Item Name: Crosstube Turning Detail

**D212-664-241/-241B
ASSEMBLY DETAIL** D

DRAWING NO. D212-664-241	TITLE CROSSTUBE ASSY (205/212 HI AFT)	REV. D	DART AEROSPACE LTD ENGINEERING ORDER		D.E.O. NO. D212-664-241-D-1	SHEET NO. SHEET 1 OF 2	SCALE NTS
DRAWN	CHECKED	MFG. APPR.	APPROVED	DE APPR.			
DATE 11.04.07	DATE 11.04.11	DATE 11.04.12	DATE 11/04/12	DATE 11.04.12

ADD AN INSPECTION WINDOW TO UNDERSIDE OF CROSSTUBE.

**D212-664-241/-241B
ASSEMBLY DETAIL**

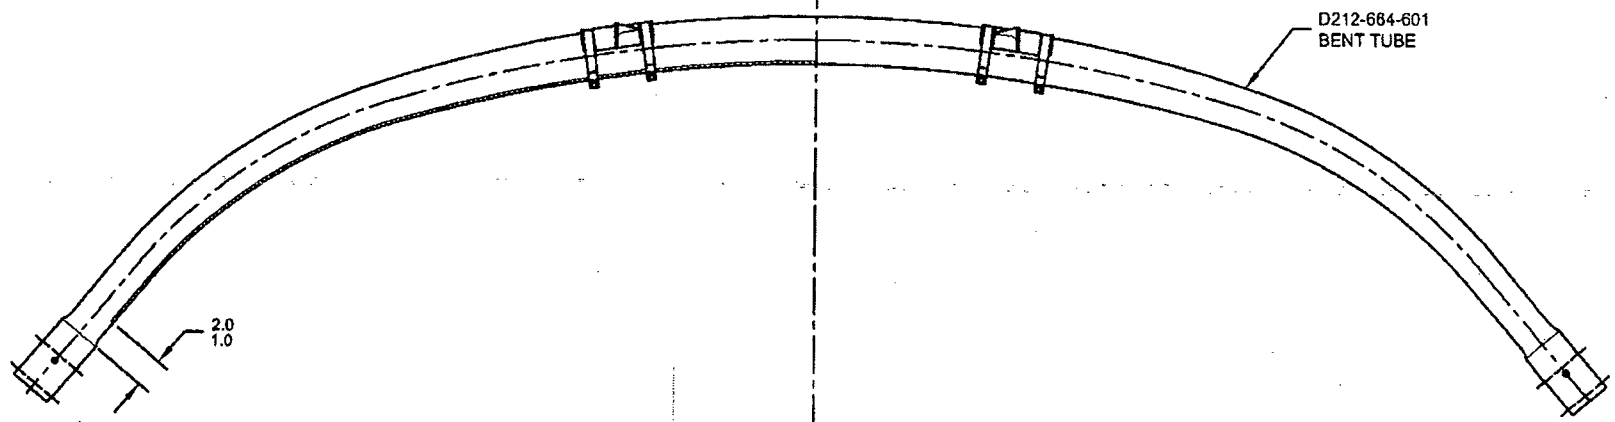
PURPOSE:

NOTES 2 OF SHEET 1 IS AMENDED AS FOLLOWS:

- 2) FINISH: CHEMICAL CONVERSION COAT PER DART QSI 005 4.1
PRIME INSIDE AND OUTSIDE PER DART QSI 005 4.2
MASK UNDERSIDE OF CROSSTUBE AS SHOWN (HATCHED AREA) AND
PAINT OUTSIDE PER DART QSI 005 4.2
REMOVE MASKING AND APPLY CLEAR COAT

- 2) FINISH: CHEMICAL CONVERSION COAT PER DART QSI 005 4.1
PRIME INSIDE AND OUTSIDE PER DART QSI 005 4.2
PAINT OUTSIDE PER DART QSI 005 4.2

MASK AREA PRIOR TO PAINTING,
REMOVE MASKING AFTER PAINT
AND APPLY CLEAR COAT
